SOLICITATION AMENDMENT MODIFICATION DE L'INVITATION

Title - Sujet CEIA HIPEPLUS/PZ/820 mm/IP 65	
Solicitation No. - N° de l'invitation 08843-180232/A	Amendment No. - N° modif. 001
Client Reference No. - N° de référence du client 20180232	Date 2019-01-22
GETS Reference No. - N° de référence de SEAG PW-\$\$PV-899-76024	
File No. - N° de dossier pv899.08843-180232	CCC No./N° CCC - FMS No./N° VME
Solicitation Closes - L'invitation prend fin at - à 02:00 PM on - le 2019-01-29	Time Zone Fuseau horaire Eastern Standard Time EST
F.O.B. - F.A.B. Plant-Usine: <input type="checkbox"/> Destination: <input checked="" type="checkbox"/> Other-Autre: <input type="checkbox"/>	
Address Enquiries to: - Adresser toutes questions à: Gauthier, Martin	Buyer Id - Id de l'acheteur pv899
Telephone No. - N° de téléphone (613) 404-8642 ()	FAX No. - N° de FAX () -
Destination - of Goods, Services, and Construction: Destination - des biens, services et construction:

Amendment 001 is raised for modifications and for Questions and Answers:

Dimensions

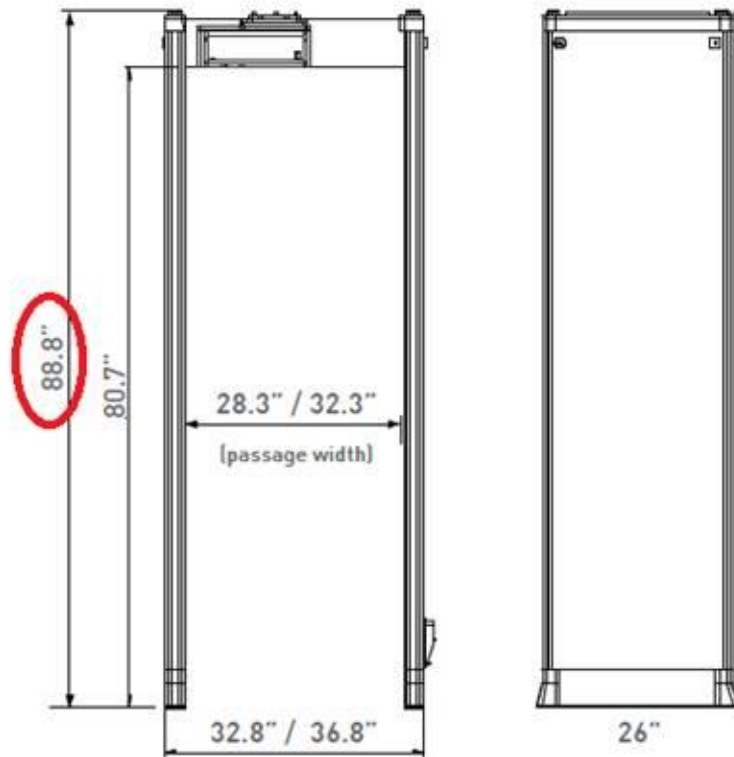
1. With regards to specification "**3. Outside overall height must be no higher than 22~~2~~5mm**":

The HIPE Plus/PZ with a 32.3" (820mm) inner passage width option has an overall total height of 88.8" (22~~5~~5.5mm). This may have been a typo, however, can you confirm that an overall total height of 88.8" (2255.5mm) is acceptable?

This is a typo...2255mm (88.8") is acceptable
